# Staff Report

**Item:** 960 Young St, "Townsend Farms" (CU 22-02)

Conditional Use CU 22-01 (Type III) with proposed site development DR 22-11 Townsend Farms building addition and variance request VAR 22-09 not to construct "Joyce Way" west half-street improvements: Commission decision.

Site plan (Sheet C002 excerpt); addition is at bottom right / south/southeast

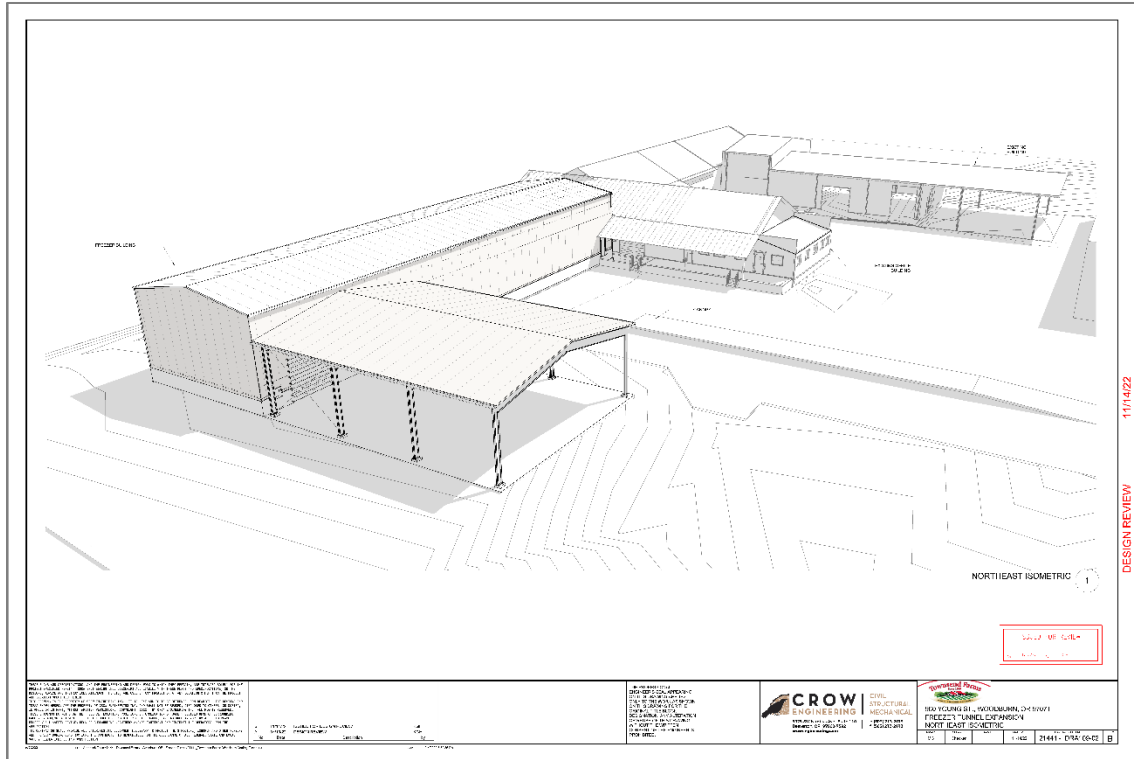
(3) Street trees: The developer shall revise the site plan Sheet C003 or equivalent:

The developer shall revise the site plans prior to building permit issuance.

*Exhibit CU3b(2)-1: Trees 1-3 from Sheet C007*

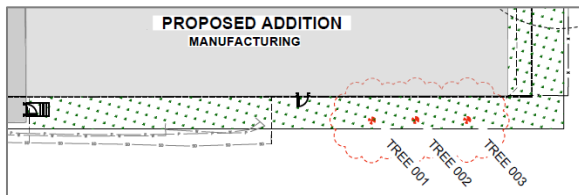
CU3. Tree preservation:

- a. ROW: n/a.
- b. On-site:
  - (1) The developer shall pay a mitigation fee for Trees 16 & 17, which Sheet C007 illustrated as proposed to be removed, per Attachment 203.
  - (2) Based on WDO 5.03.01B.3c5), the developer shall replace Trees 1-3 proposed to be removed with two coniferous/evergreen trees at minimum size at planting per Table 3.06B and in the same 10-foot wide easterly south yard along the building addition.

Exhibit V1a-1 Sheet C004 Fire apparatus roads

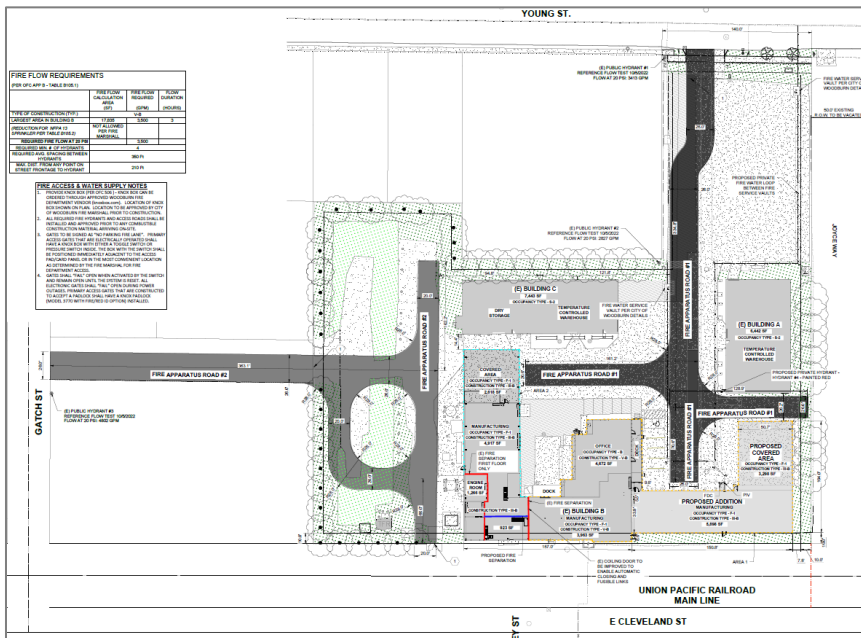
V1. Joyce Way west half-street improvements variance: Fire apparatus road #1: The request to vary from Woodburn Development Ordinance (WDO) 3.01.03A & C.1, Figure 3.01A, 3.01.04B.1, and Figure 3.01G regarding the unnamed paper street right-of-way (ROW) at the east that City staff terms “Joyce Way” is approved, but with provisions as follows and, where conflicting with Condition G4, superseding:

- a. Objective: The objective of this condition is to have Townsend Farms improve or pay for improved fire access as follows: Upon either DR 22-06 1030 Young Street residences development or any redevelopment of that property that constructs a Joyce Way east half-street similar to how land use review Sheet PP-2 illustrated providing access to 1030 Young Street, then Townsend Farms shall per Woodburn Fire District (WFD) administration of the Oregon Fire Code (OFC) improve the gap between the half-street and the east dead-end of fire apparatus road #1 as CU 22-02 land use review Sheet C004 illustrated it and install a gate and emergency key box.

- b. Due date: Per the WFD Fire Marshal, yet no later than before issuance of the first certificate of occupancy (C of O) for a 1030 Young Street redevelopment. The City delegates administration of this fire access condition to the WFD Fire Marshal, and after the developer and the Fire Marshal implement the condition, the developer shall submit to City staff documentation that the WFD considers the condition met, whether through improvement or fee in-lieu.

- e. The developer shall revise the site plans prior to building permit issuance.

*Exhibit CU3b(2)-1: Trees 1-3 from Sheet C007*

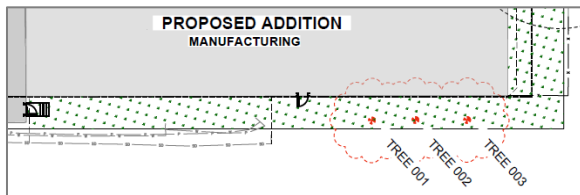
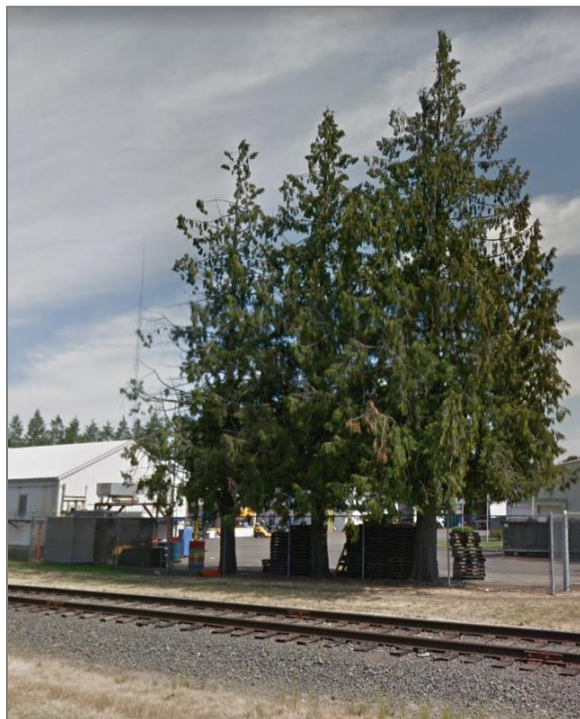
CU3. Tree preservation:

- a. ROW: n/a.
- b. On-site:
  - (1) The developer shall pay a mitigation fee for Trees 16 & 17, which Sheet C007 illustrated as proposed to be removed, per Attachment 203.
  - (2) Based on WDO 5.03.01B.3c5), the developer shall replace Trees 1-3 proposed to be removed with two coniferous/evergreen trees at minimum size at planting per Table 3.06B and in the same 10-foot wide easterly south yard along the building addition.

Exhibit V1a-1 Sheet C004 Fire apparatus roads

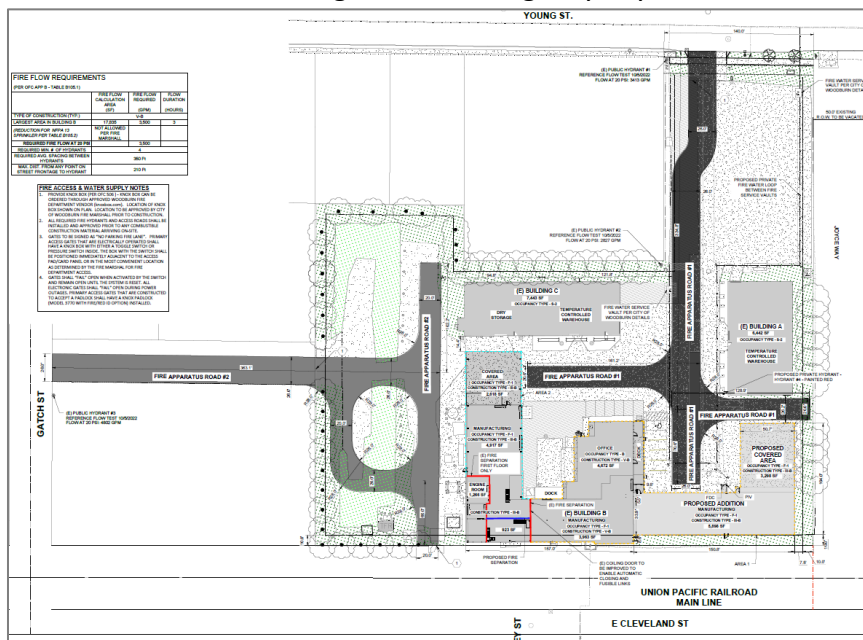
V1. Joyce Way west half-street improvements variance: Fire apparatus road #1: The request to vary from Woodburn Development Ordinance (WDO) 3.01.03A & C.1, Figure 3.01A, 3.01.04B.1, and Figure 3.01G regarding the unnamed paper street right-of-way (ROW) at the east that City staff terms “Joyce Way” is approved, but with provisions as follows and, where conflicting with Condition G4, superseding:

- a. Objective: The objective of this condition is to have Townsend Farms improve or pay for improved fire access as follows: Upon either DR 22-06 1030 Young Street residences development or any redevelopment of that property that constructs a Joyce Way east half-street similar to how land use review Sheet PP-2 illustrated providing access to 1030 Young Street, then Townsend Farms shall per Woodburn Fire District (WFD) administration of the Oregon Fire Code (OFC) improve the gap between the half-street and the east dead-end of fire apparatus road #1 as CU 22-02 land use review Sheet C004 illustrated it and install a gate and emergency key box.

- b. Due date: Per the WFD Fire Marshal, yet no later than before issuance of the first certificate of occupancy (C of O) for a 1030 Young Street redevelopment. The City delegates administration of this fire access condition to the WFD Fire Marshal, and after the developer and the Fire Marshal implement the condition, the developer shall submit to City staff documentation that the WFD considers the condition met, whether through improvement or fee in-lieu.

960 YOUNG ST., WOODBURN, OR 97071  
CIVIL DRAWINGS  
TREE PROTECTION AND REMOVAL PLAN

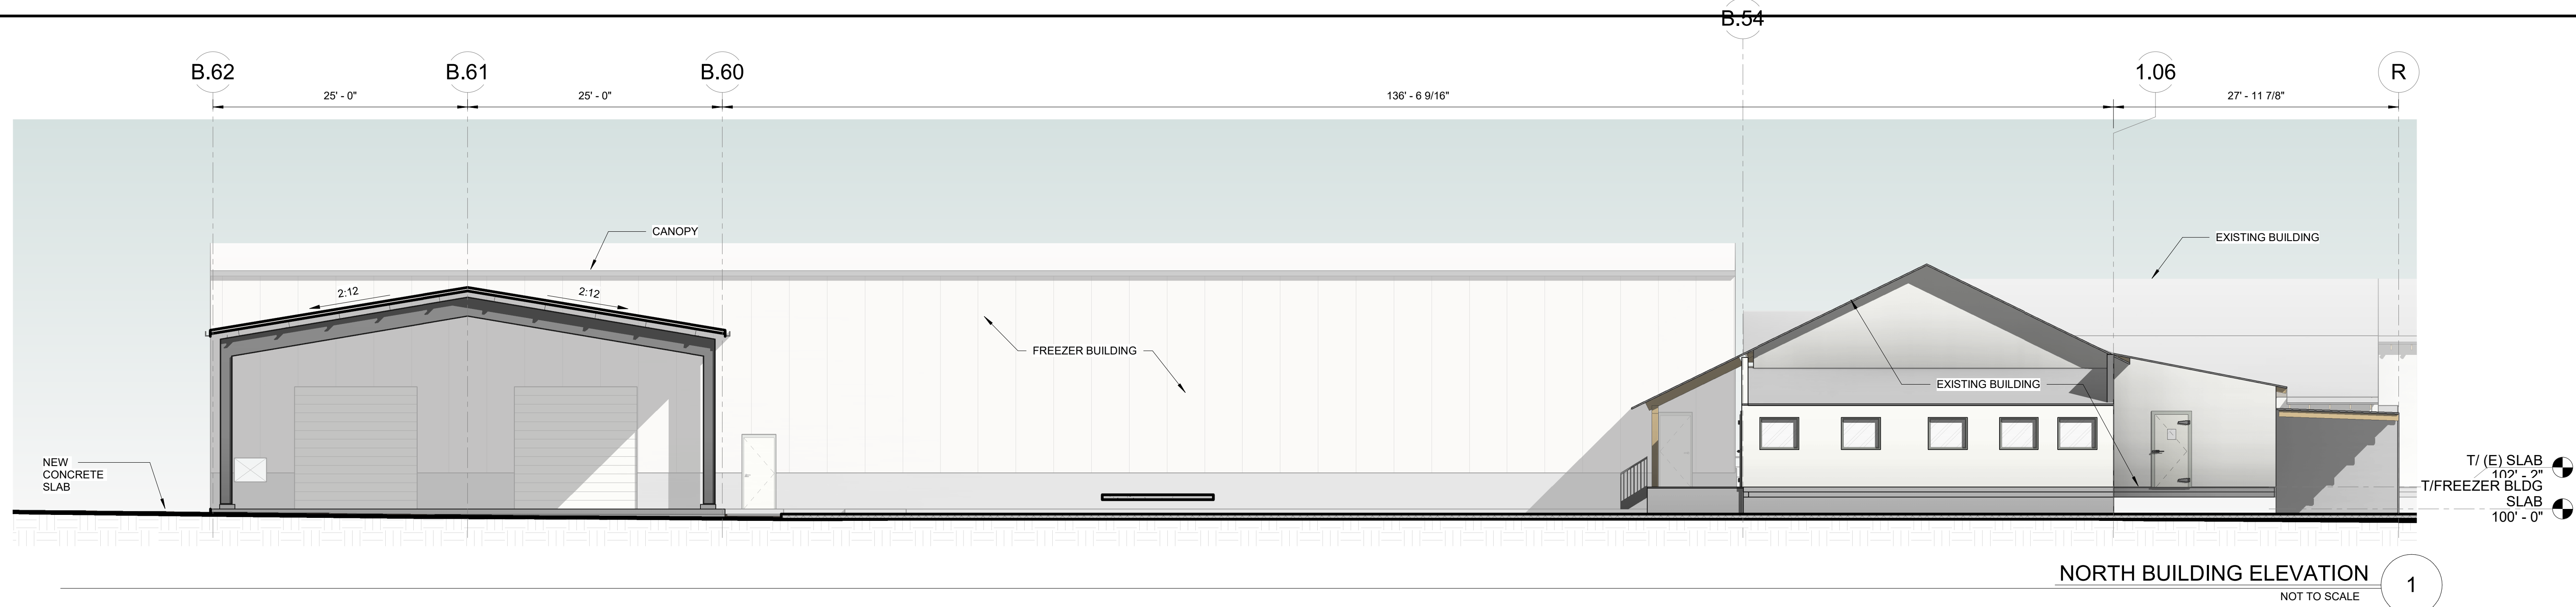
Landscape plan Sheet C005 shows alteration and Sheet C007 shows tree protection and removal and that there are 21 Significant Trees of which the applicant proposes to remove 11. Of the 11, 5 are in poor condition or dying. (The applicant submitted an arborist report dated October 14, 2022 on November 15, 2022.) Of the remaining 6 proposed to accommodate the proposed addition and utilities, staff determines that 5 – Trees 1-3, 16, & 17 – should be mitigated and conditions accordingly.
